**JOINT REGIONAL PLANNING PANEL
(Sydney Region East)**

JRPP No	2013SYE059
DA Number	187/13
Local Government Area	NORTH SYDNEY COUNCIL
Proposed Development	STAGED 1 CONSTRUCTION OF 16 STOREY MIXED USE DEVELOPMENT AT 22 ATCHISON STREET AND STAGE 2 BUILDING ENVELOPE CONCEPT APPROVAL FOR NO.20 ATCHISON STREET, ST LEONARDS
Street Address	20 & 22 ATCHISON ST LEONARDS
Applicant/Owner	RADACA INVESTMENTS PTY LTD (20 ATCHISON) & PRIME CITY PROPERTIES PTY LTD (22 ATCHISON STREET)
Submissions	3
Recommendation	Approval with Conditions
Report by	Lara Huckstepp, Executive Planner

ASSESSMENT REPORT AND RECOMMENDATION

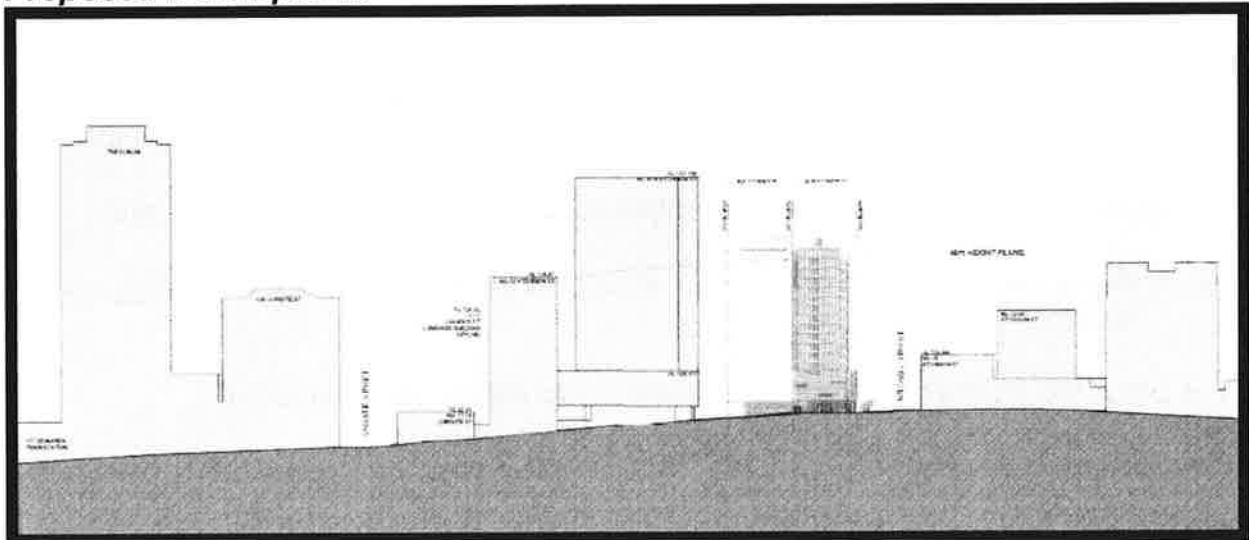
The proposed development results in an overall building height of 58.95m which occurs at the roof plant and common area. It is noted that the height of the roof over the uppermost residential level has a maximum height of 52m. The applicant has submitted a SEPP1 Objection in relation to the breach. The proposal is considered against the objectives of Clause 29 of NSLEP 2001 below:

- As set out within this report, a condition is recommended to address overshadowing to delete the eastern blade walls above rooftop level, the lower the building by 400mm by reducing the ground level floor to ceiling levels, and to reduce the length of the common room on the roof. Subject to these amendments, there are considered to be no material overshadowing impacts resulting from the development.
- There are no material privacy or view impacts caused by these structures.
- The structures are appropriately articulated and set back from the common boundary subject to conditions outlined above.
